COAXIAL CABLE MAINTENANCE

PRECAUTIONS

NOTES CONCERNING THIS ADDENDUM

This addendum supplements G74. 440 to provide information on reference and tool changes, and is being reissued to cancel information on coaxial terminals that is now covered in the G61 series.

Figure 1

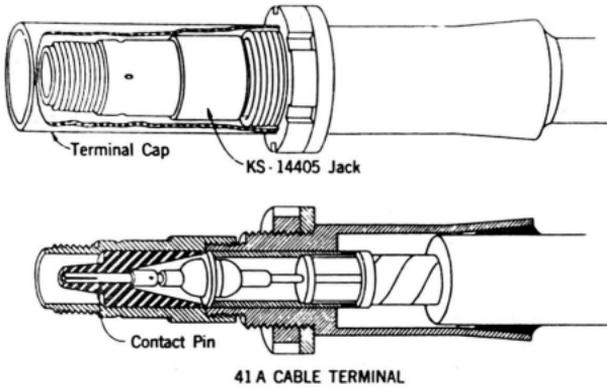
2.04 30B Cable Terminals are used to terminate coaxials at main repeater stations and terminal offices on the L1 system in the Southern California Area. This terminal was replaced with the 30C which is superseded by the 41A cable terminal. When converting from the L1 to the L3 system it is necessary to modify the 30B terminals or replace them with the 41A terminal. See Figure 1.

Figure 2

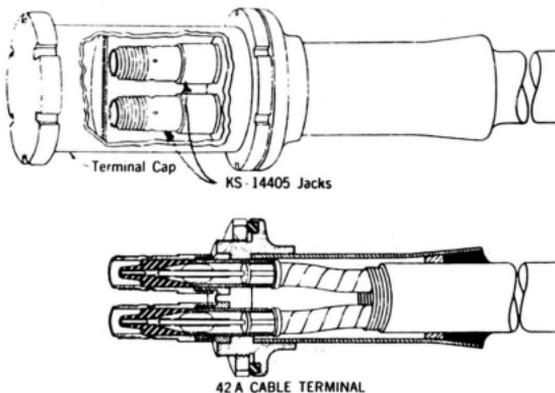
2.05 31A Coaxial Cable Terminal replaced by 31B which has been superseded by the 31C terminal is used to carry coaxials into and out of the associated repeaters at auxiliary repeater points. 31B cable terminals must be modified when converting L1 carrier-systems to the L3 system. Where a 31B terminal must be replaced, it should be replaced with a 31C-type and this terminal modified accordingly.

Note: 42A cable terminals are used on the more recent L3 carrier systems. See Figure 2.
